UNITED STATES PATENT AND TRADEMARK OFFICE

APPLICATION NO.	FILING DATE	FIRST NAMED INVENTOR	ATTORNEY DOCKET NO.	CONFIRMATION NO.
10/500,926	03/11/2005	Dac-Hwan Kim	1592-4043	8948

Office Action Summary	Application No. 10/500,926	Applicant(s) KIM, DAE-HWAN	
	Examiner Noah C. Hawk	Art Unit 3636

DETAILED ACTION

Mallookis et al., Figure 5

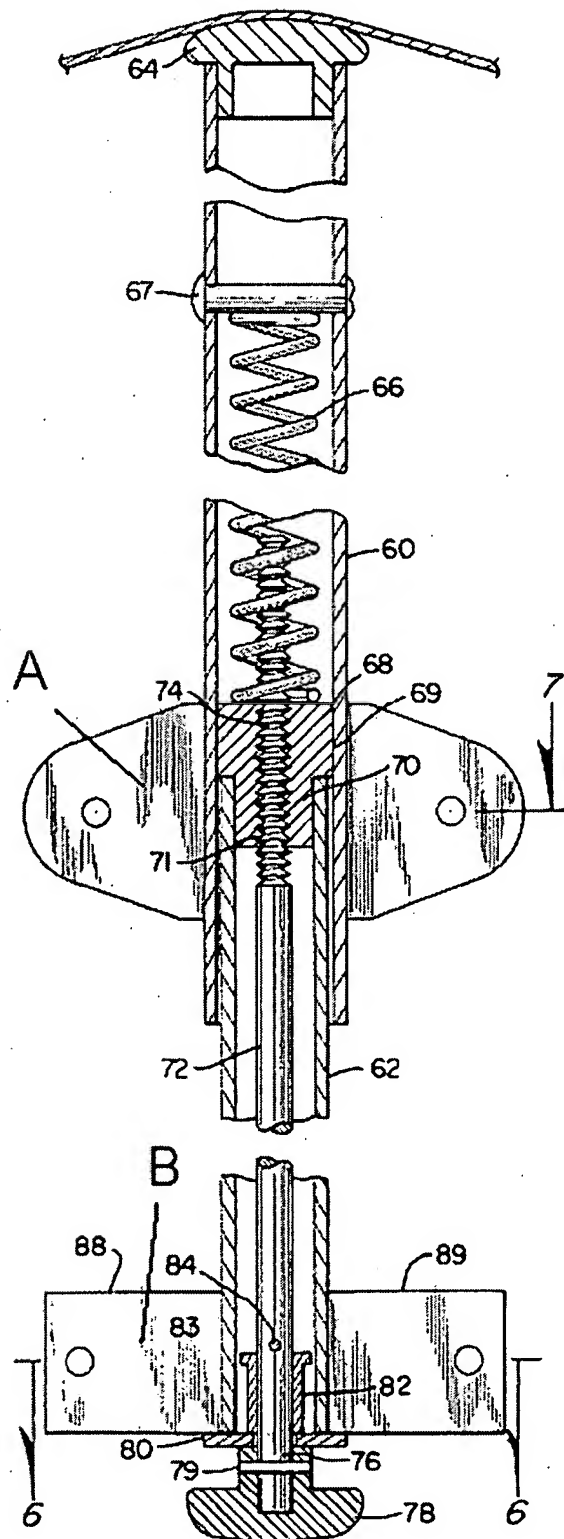
7. Claim 10 is rejected under 35 U.S.C. 103(a) as being unpatentable over Lynch, as modified, as applied to claim 1 above, and further in view of Mallookis et al. in US Patent 5490532. Lynch, as modified, fails to teach an adjustable upper roof column. Mallookis teaches wherein an upper roof column (60) capable of sliding along the upper head connection block (A) is installed on the lower head connection block (B) by penetrating the upper head connection block, an elastic spring (66) is installed under the upper roof column and in a lower roof column to enable height adjustment by erecting the upper roof column, and a rotary handle (78) is installed on the lower head connection block capable of freely rotating to adjust the displacement of the elastic

spring and having one end portion penetrating the elastic spring and fixed to an end portion of the elastic spring capable of freely rotating and the other end portion capable of advancing and retreating by mean of a nut (68) and a screw (74) with respect to the lower head connection block during rotation. It would have been obvious to one of ordinary skill in the art at the time of invention to modify the device of Lynch, as modified, by using an adjustable upper roof column as taught by Mallookis et al., in order to provide "optimum tautness" and an "easily adjusted" tension (see Mallookis, Column 1, lines 55-58) in the cover.
